GUERNSEY FARMS DAIRY REMODEL JSP19-41

Consideration at the request of McGuire Brothers, LLC for Planning Commission's approval of Preliminary Site Plan and Storm Water Management plan. The subject property is located eastside of Novi Road north of Eight Mile Road. The applicant is proposing to make some interior changes to restaurant seating layout and outdoor seating area. The plan also proposes a number of changes to exterior site layout and traffic circulation by reducing the number of curb cuts along Novi Road. It also proposes an alternate location for 'Welcome to Novi' sign along its frontage.

PLANNING REVIEW

Review Date: December 12, 2019
Review Type: Preliminary Site Plan
Project Name: **JSP 19-41 Guernsey Dairy Farm Remodel**
Plan Date: November, 2019
Prepared by: Sri Ravali Komaragiri
Contact: **E-mail:** skomaragiri@cityofnovi.org **Phone:** 248.735.5607

Sheet Title:
LANDSCAPE PLAN

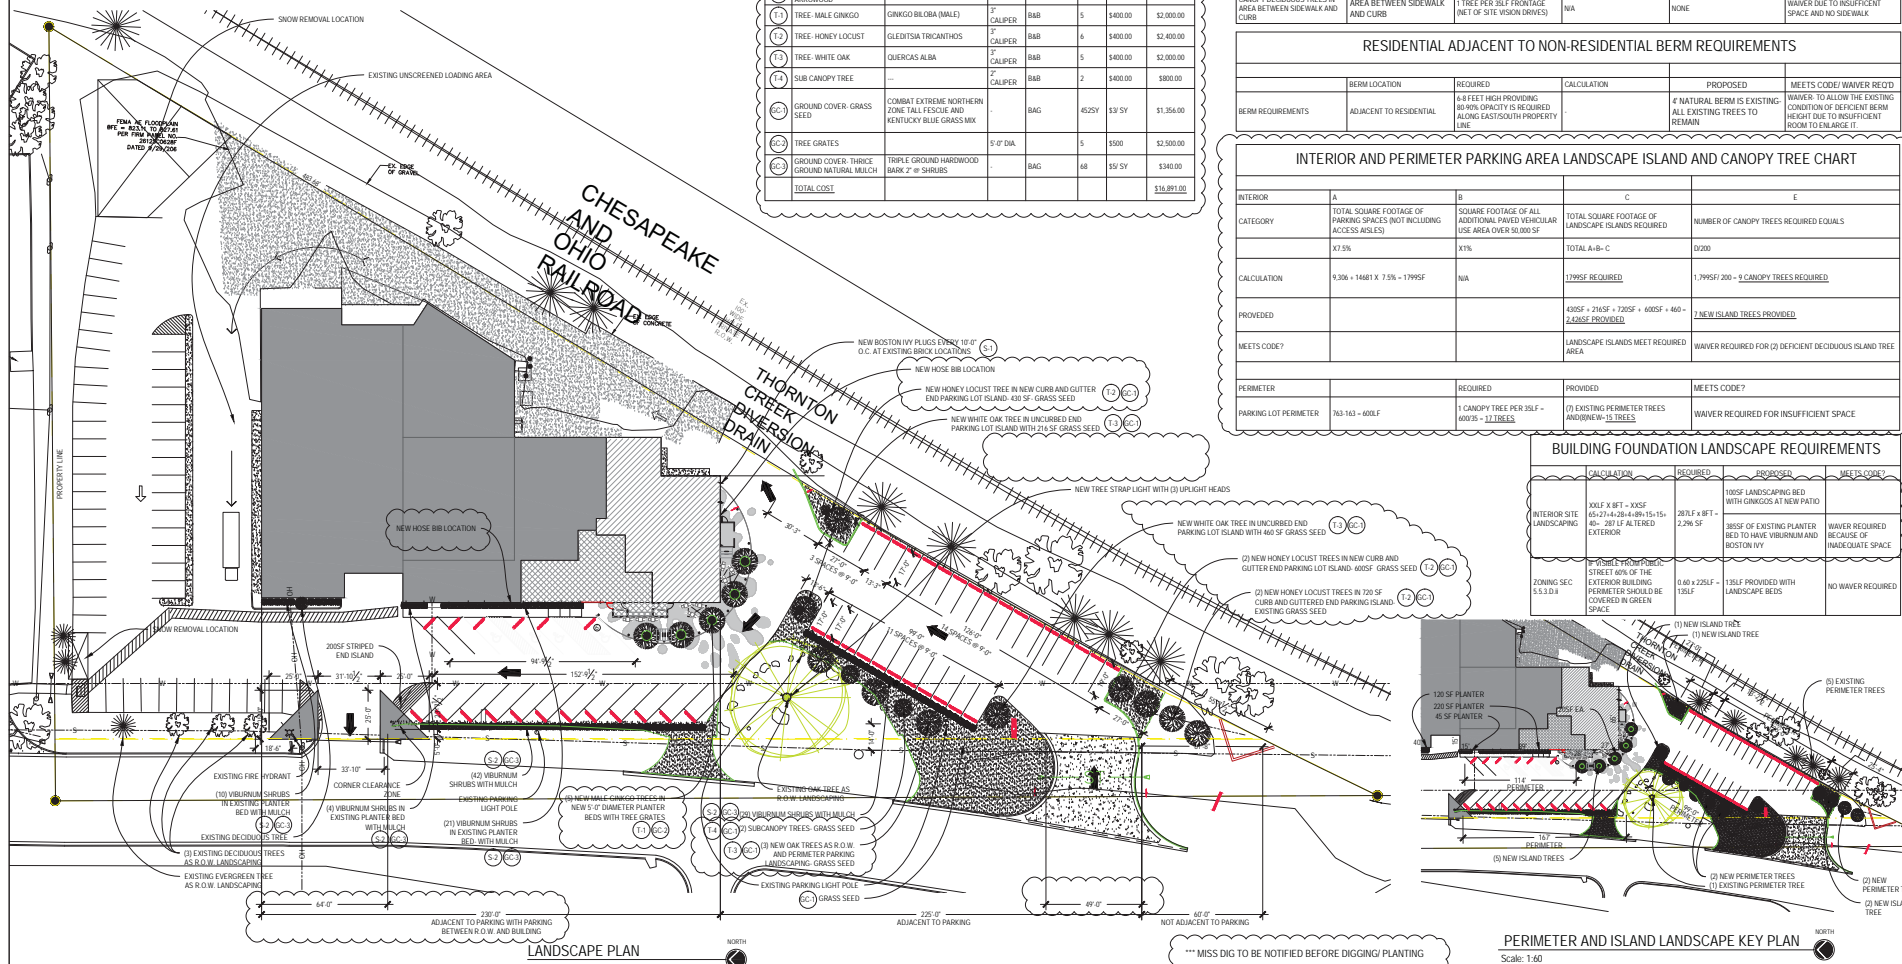
Please provide a list of all landscape waivers requested that includes the impact (ie deficiency in area or trees provided) on sheet Ip101.

1. Please provide a list of all landscape waivers requested that includes the impact (ie deficiency in are of trees provided) on sheet LP101-
A list of all landscape waivers is provided on Sheet LP101

A landscape waiver has been added to Sheet LP101

The Landscape Plan on Sheet LP101 has been modified to add (3) additional white oak trees and (2) additional native subcanopy trees in the new landscaping area south of the existing oak tree. As well as the ROW screening requirements chart. A landscape waiver has been added to Sheet LP101 for these items

COVER SHEET

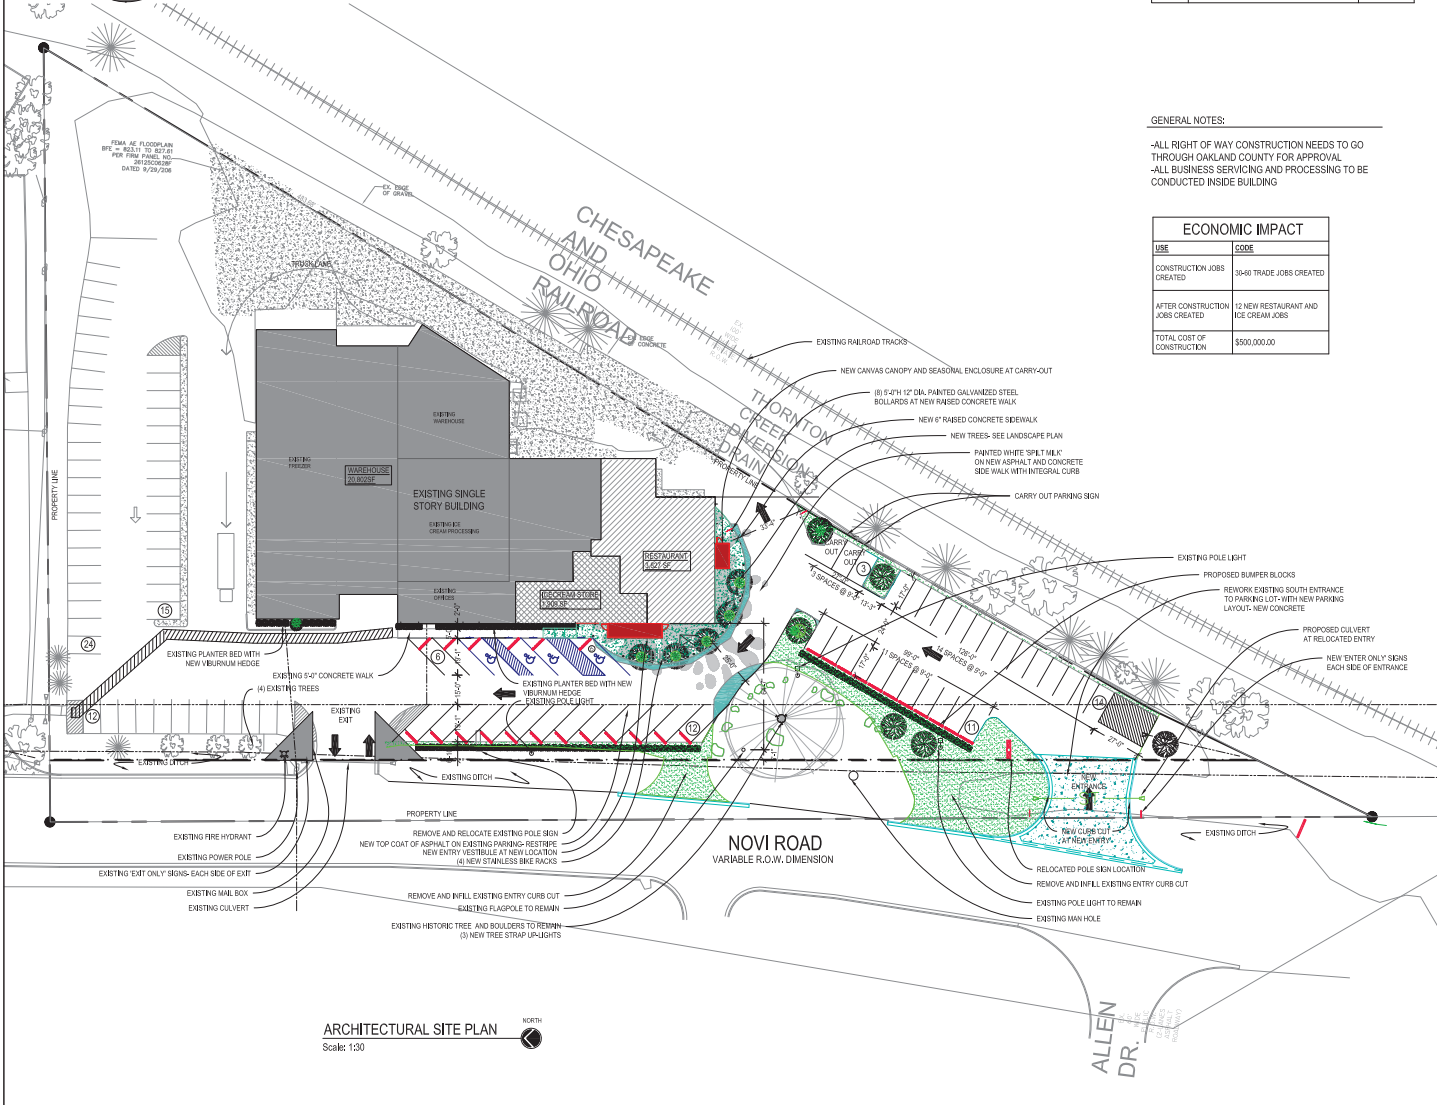
- iii. The applicant should include details for the proposed carry-out signing shown on sheet G001.
- 2. The applicant should indicate all of the proposed signing on site and provide notes and details related to the proposed signing.

8. *The applicant is proposing painted white “spilt milk” markings on sheet Goo1. Details for this should be included in future submittals and a waiver may be required.
*If a waiver is required we shall be going in for this waiver. A detail shall be added**
9. *The applicant should include any maintenance of traffic details required when working along Novi Road.
*These details shall be added**

- ii. The applicant should include proposed signing for the one-way operation.
Detail will be added
 - iii. The applicant should include details for the proposed carry-out signing shown on sheet Goo1.
Detail will be added

SHEET NUMBER
C2.0

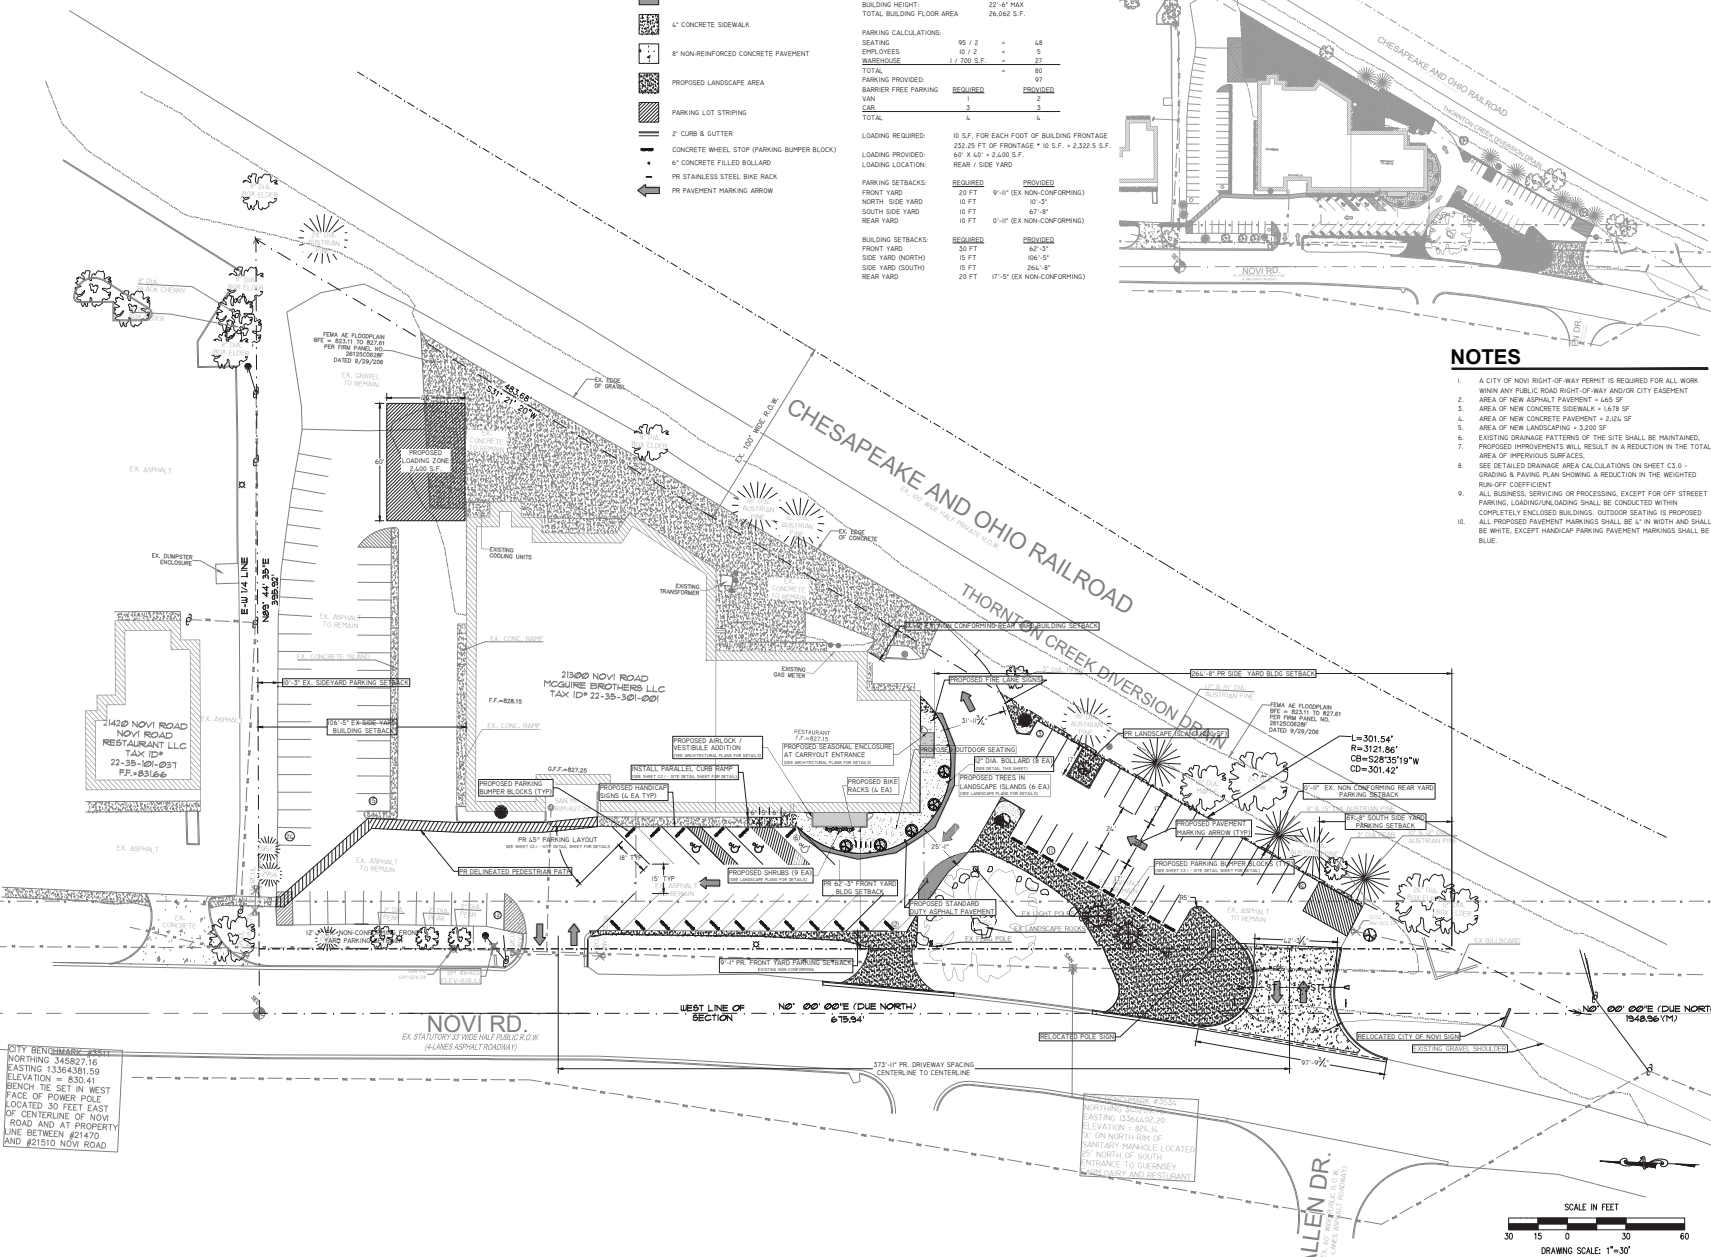
4. The applicant has indicated that the traffic through the new parking area is to be one-way. However, the driveway servicing the area is indicated to be two-way on sheet C2.0. The applicant should revise the plans to match the one-way operations.

- c. Sheet G001 refers to a painted island to the south of northern entryway (see below). It is not consistent in the sheet set. For example, sheet C2.0 do not show the painted island.
The drawings will be modified to show the painted island

Sheet C2.0 will be labeled accordingly
 - b. Sheet G001 refers to one-way circulation. All other sheets refer to two way entry at two proposed curb cuts. Please revise to be consistent.
The other sheets will be revised to show one way circulation

4. The applicant has indicated that the traffic through the new parking area is to be one-way. However, the driveway servicing the area is indicated to be two-way on sheet C2.o. The applicant should revise the plans to match the one-way operations.
The plans have been revised to show the one way arrows and signs at new entry and existing exit

SHEET NUMBER:
C2.1

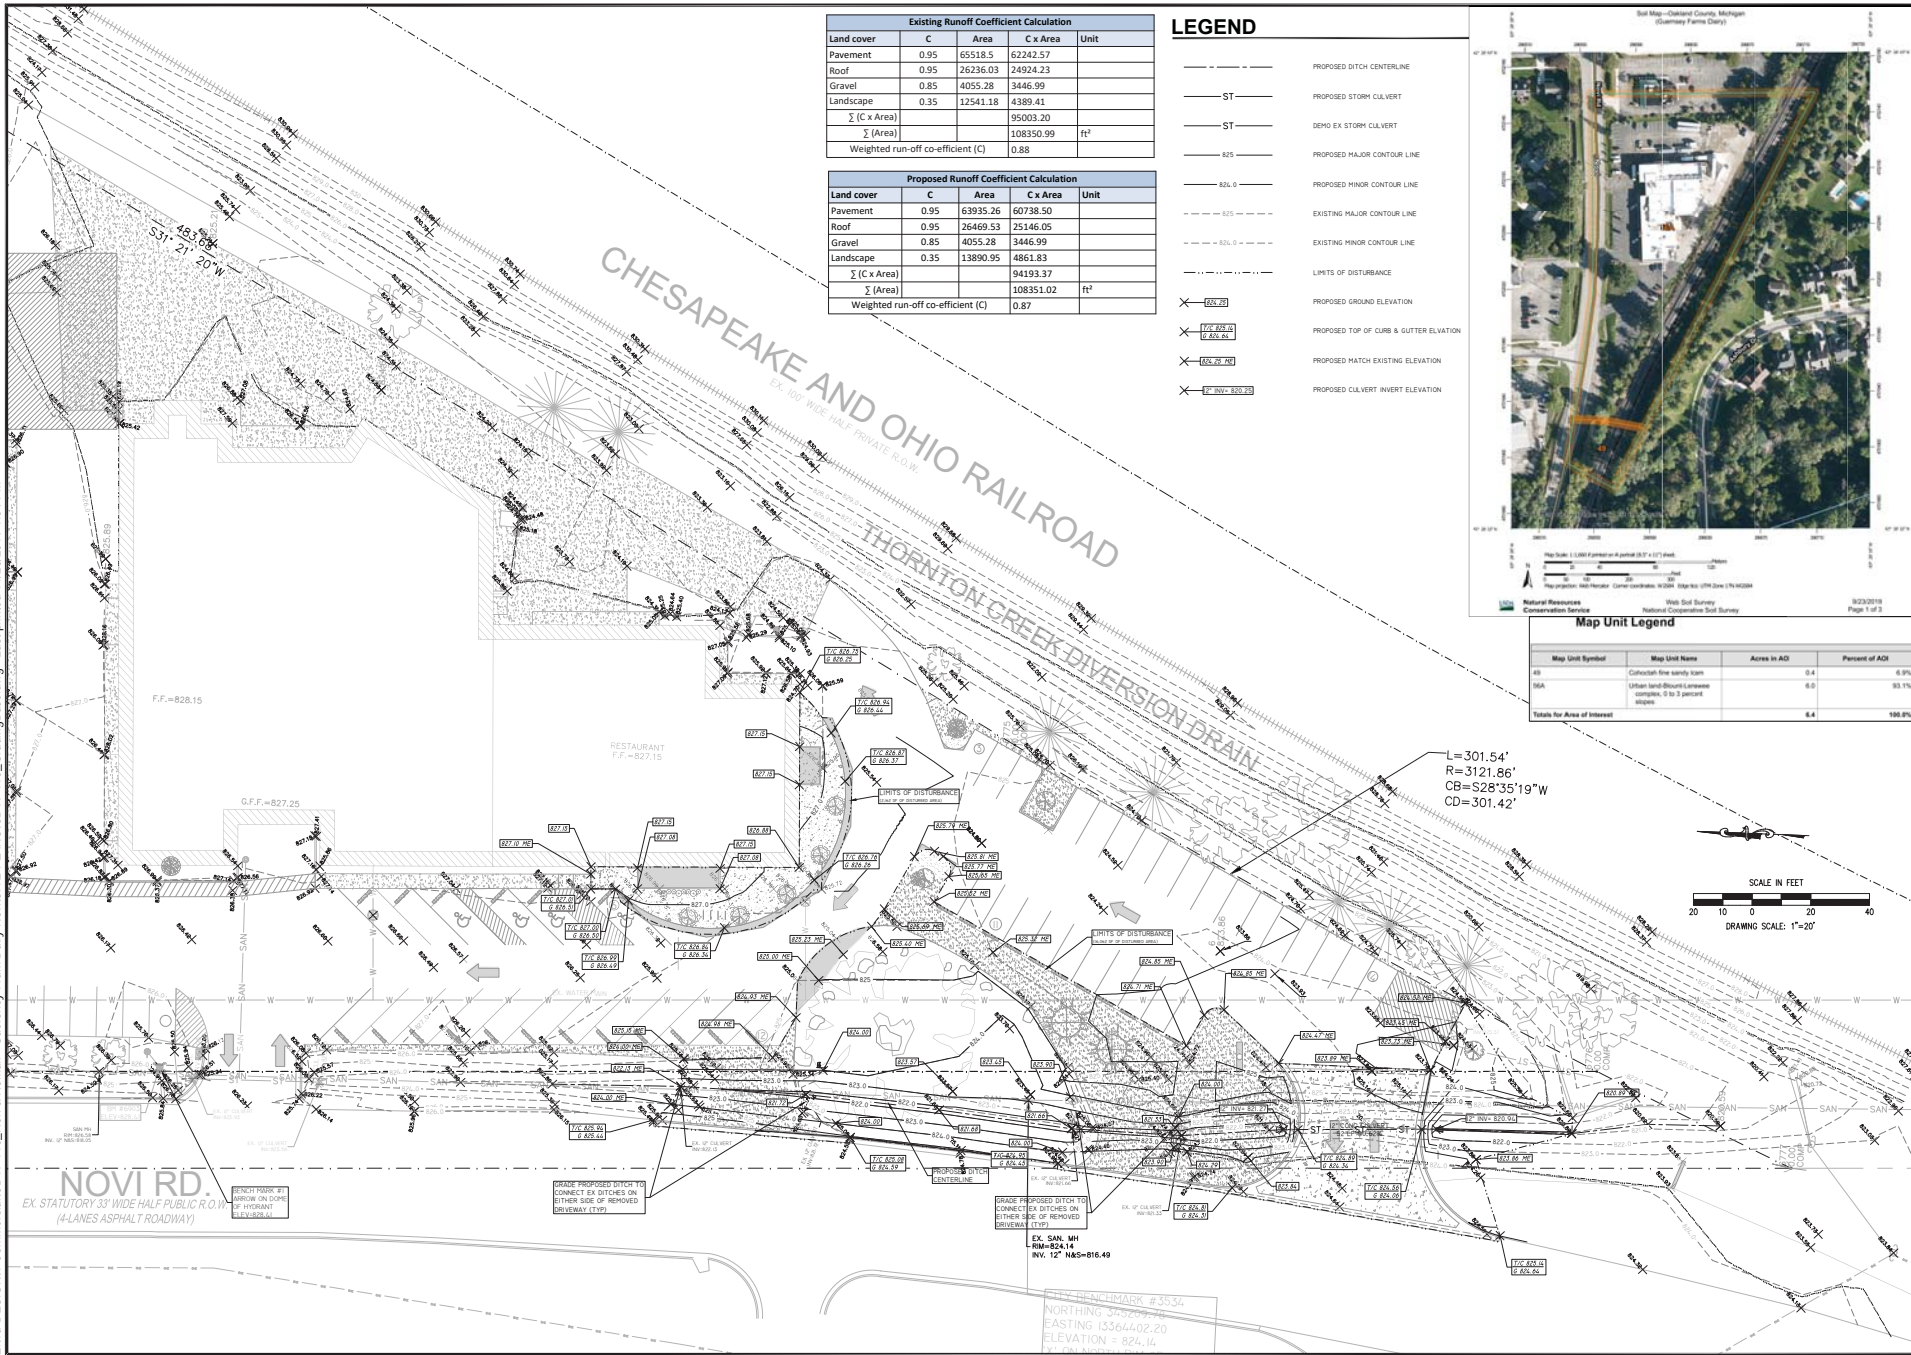
- i. The applicant should indicate which spaces are van accessible with appropriate signage. One (1) space is required to be van accessible.
 - ii. The detail for the accessible spaces on sheet C2.1 should be updated to account for the angled parking condition present in the site plan.

- ii. The detail for the accessible spaces on sheet C2.1 should be updated to account for the angled parking condition present in the site plan.
The detail has been updated on Sheet C2.1

- ii. Parking bumpers are to be yellow in color.
Noted
 - iii. Parking bumpers are to be placed such that the face of the parking bumper is 17 feet from the access aisle. Current detail specifies the back of the parking bumper is to be located two (2) feet from the back of the parking space, leaving only 14.5' for the parking space with the 17' spaces specified in the site plan. The detail should be updated.
The angled parking detail has been added to Sheet C2.1 showing 17'-0" to bumper block
